**ZONING MAP CHANGE
STAFF REPORT**

Site Location: 5900 block of Jerry Dunn Pkwy Acreage: 16.8

Proposed Use: **Detached Multifamily**

PD SITE PLAN
PMB SFR FW

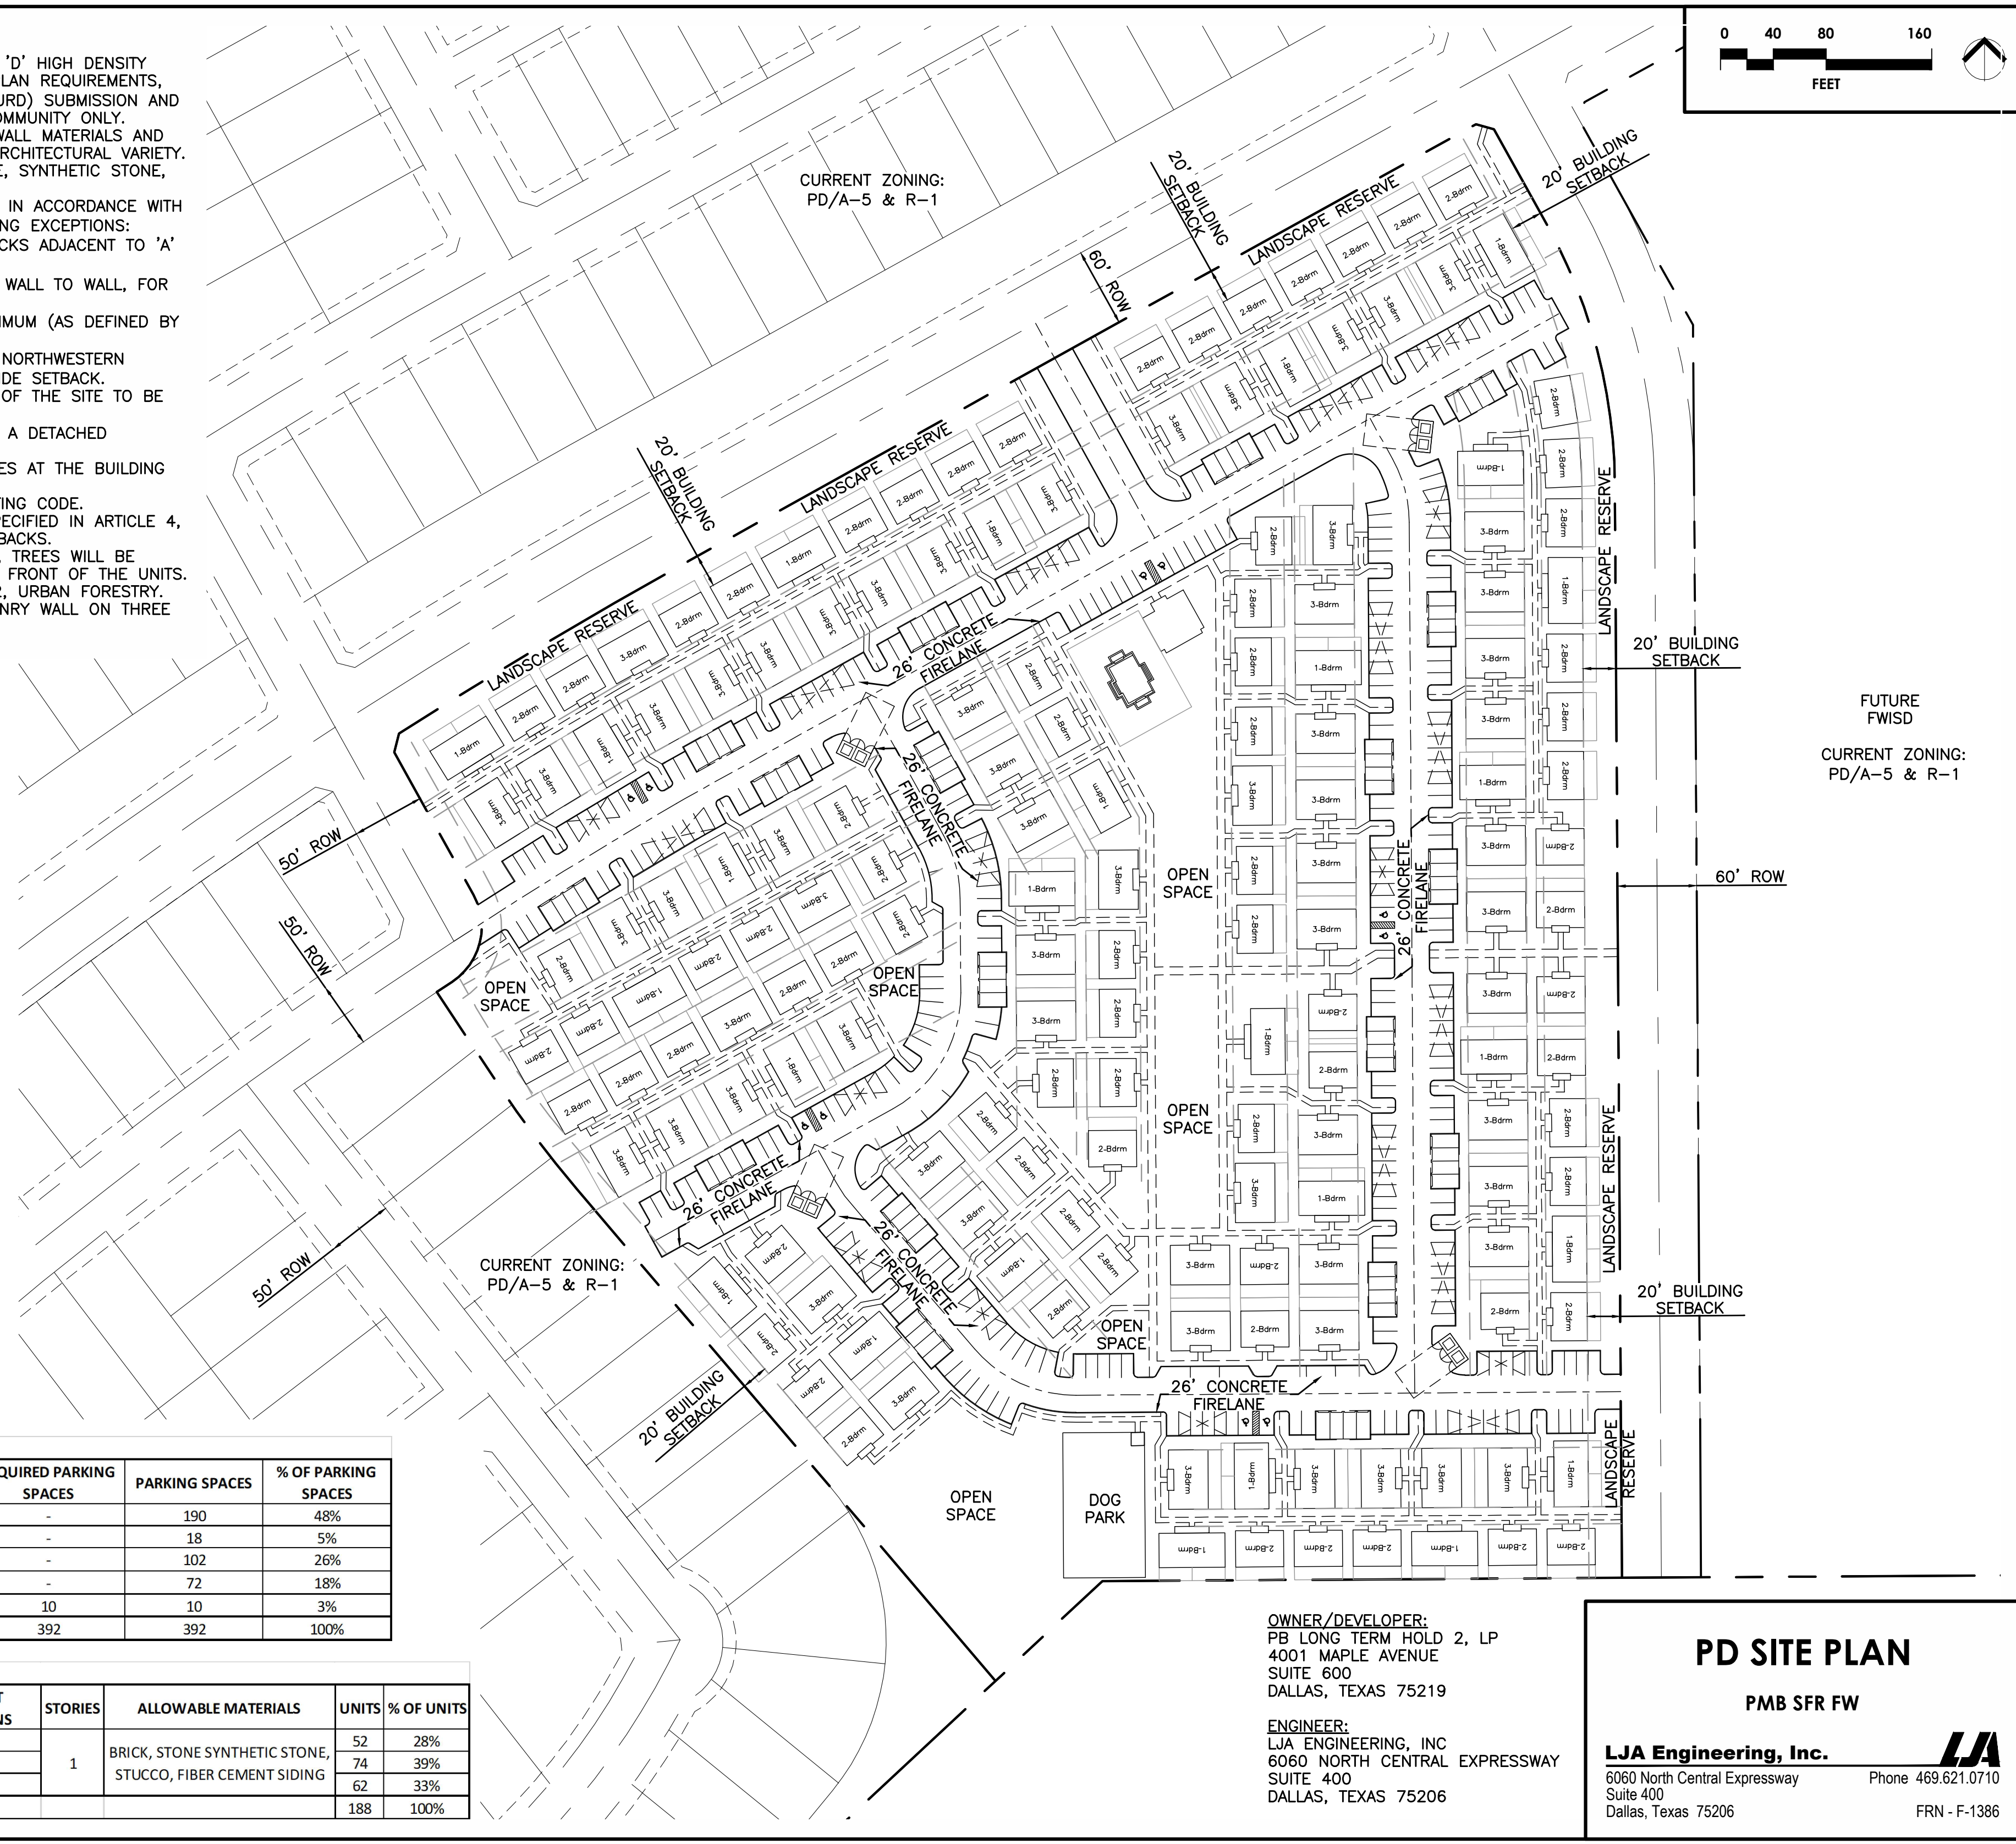
1. The building orientation requires all building to have their longest side facing the adjacent street. **(Development Regulation Standard)**
 - *Analysis: Based on the proposed detached multifamily not being individual detached units and not typical multifamily layout, staff supports the building orientation layout.*

2. Setbacks adjacent to A or B districts is 3:1 with a 30' minimum. Maximum building height is 17' which requires a 51' setback **(Development Regulation Standard)**

3. Landscaping must meet 20 points of enhanced landscaping along public ROWs. Most of this development fronts local streets and the impact of public frontage enhanced landscaping is not as impactful as site landscaping spaced throughout the development more similar to single family landscaping of one tree in the front yard. **(Development Regulation Standard)**

- *Analysis: Based on the configuration of the site and the development not being a typical multifamily design, staff supports the new setback regulations as the project has a scale closer to single family.*

- *Analysis: Based on the configuration of the site and the development not being a typical multifamily design, staff supports the new setback regulations as the project has a scale closer to single family.*
